# 320 TODD ROAD DEVELOPMENT

## CIVIL CONSTRUCTION PERMIT

SHEET TITLE  
**Storm Details**

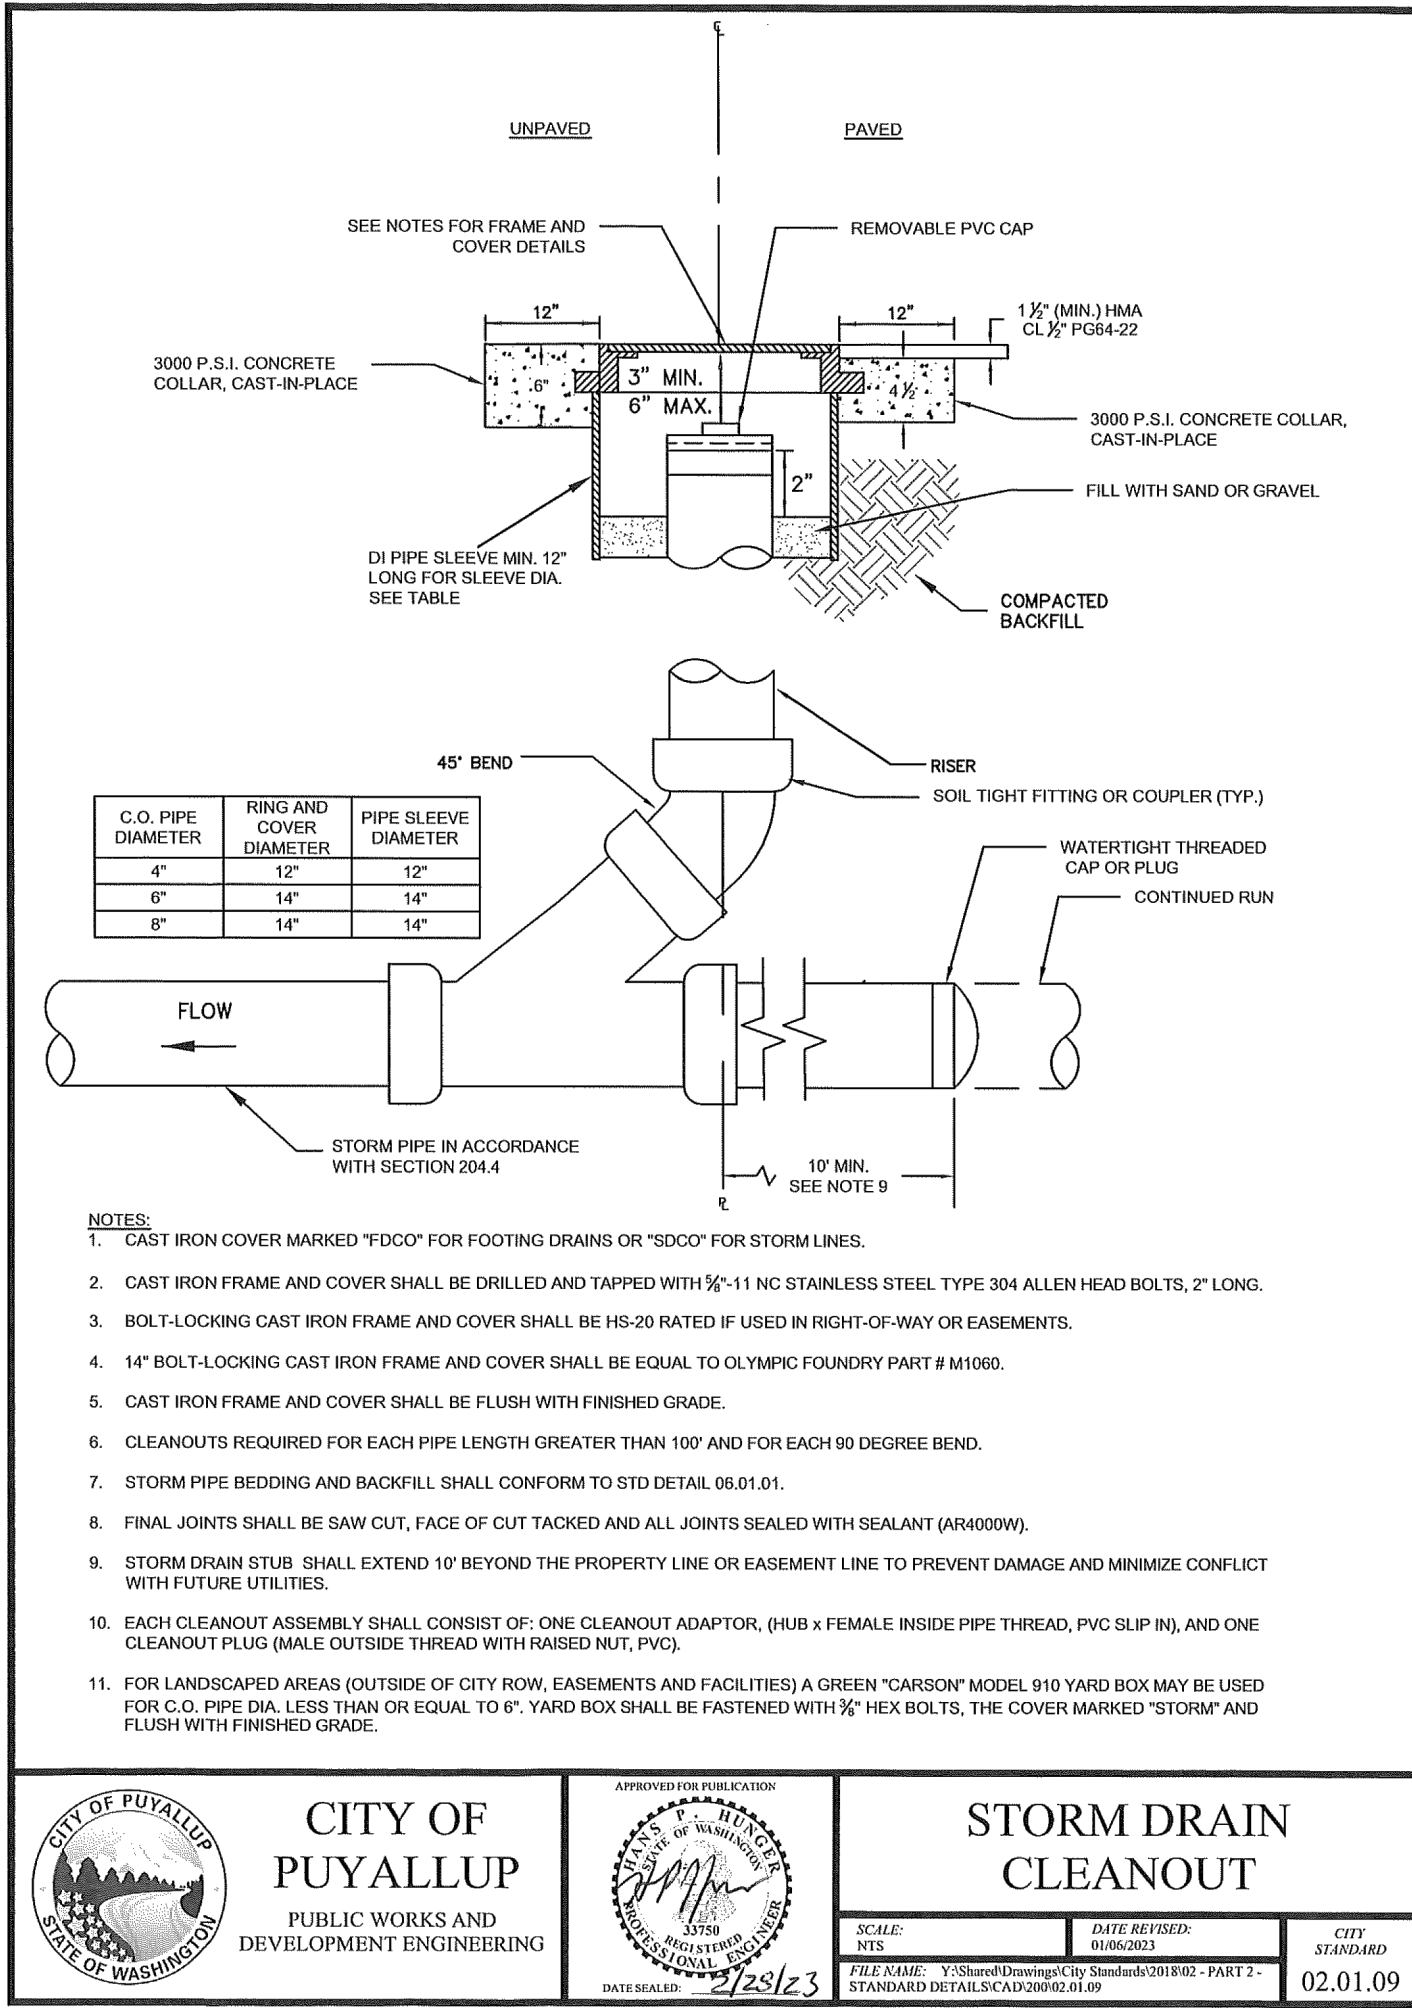
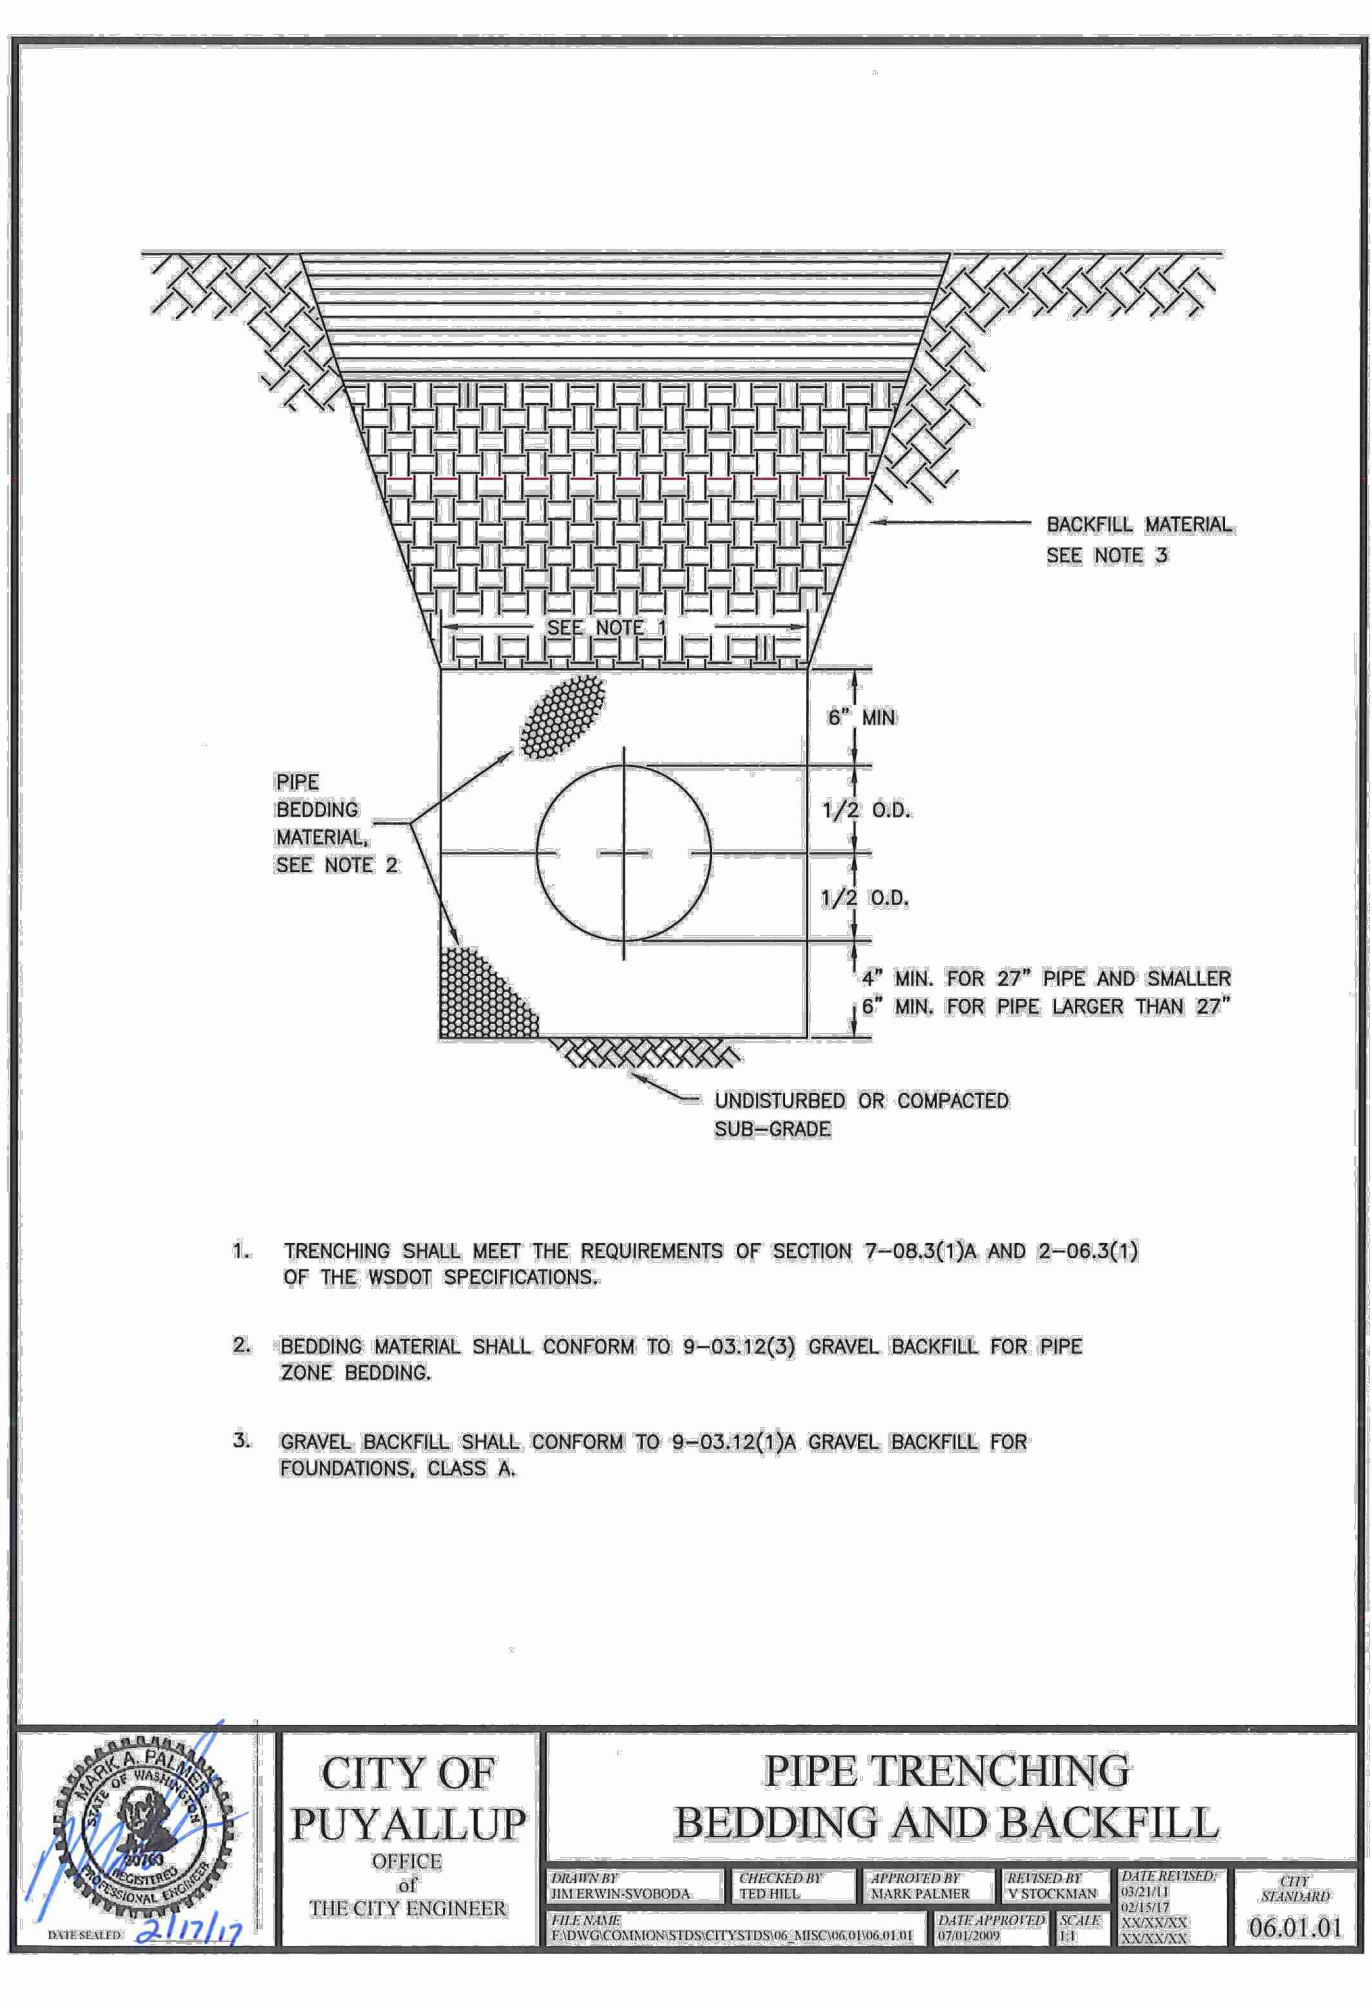
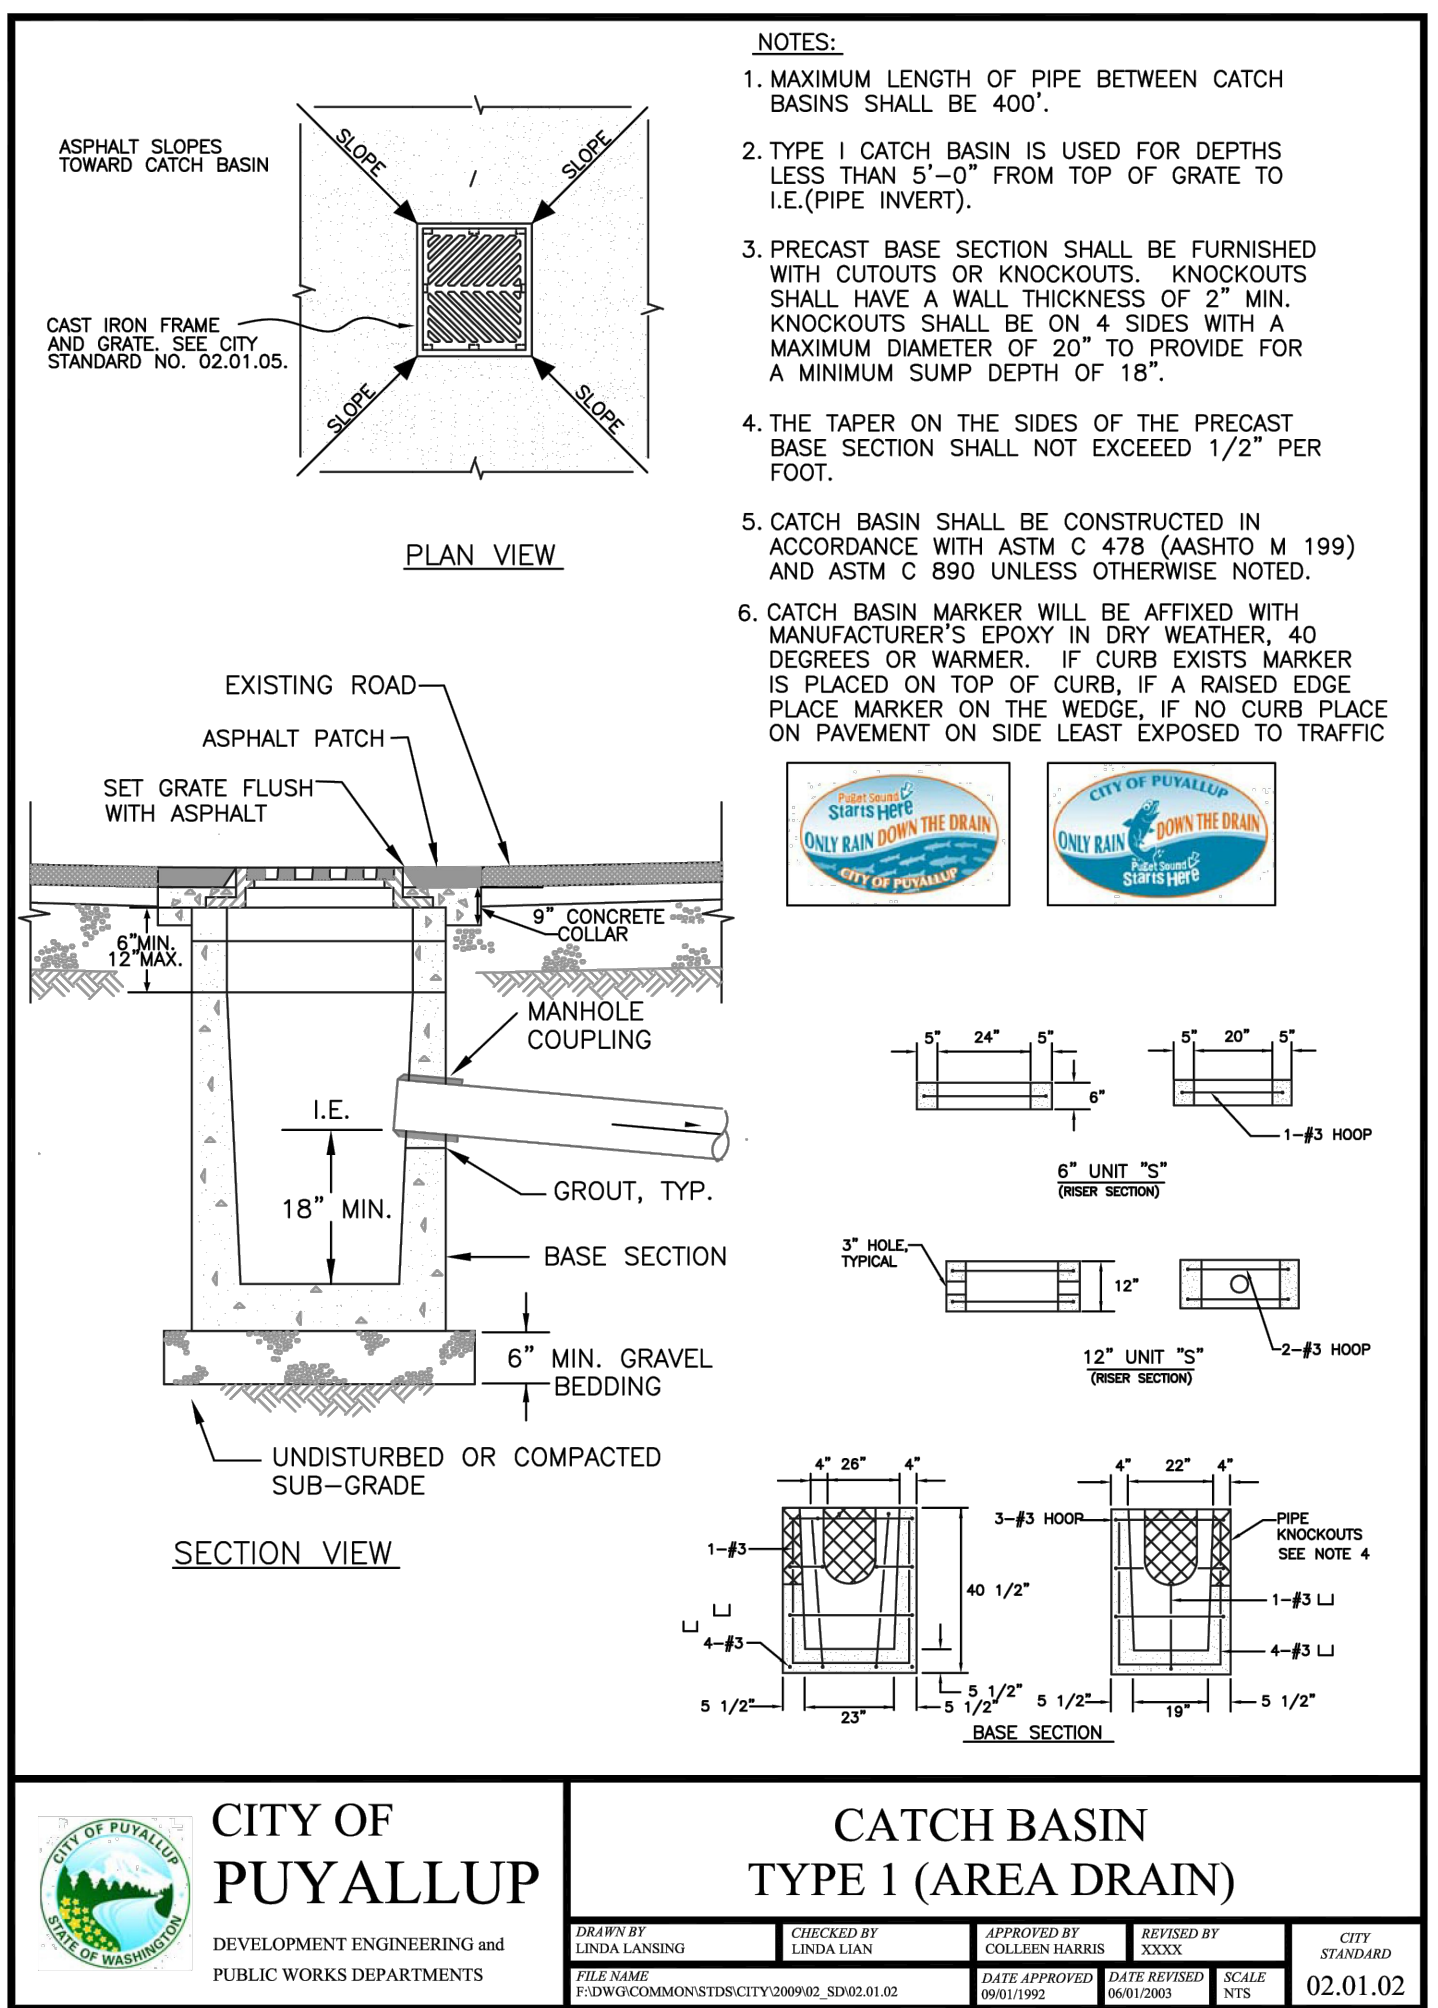
Include Details 02.01.03 and 02.01.05
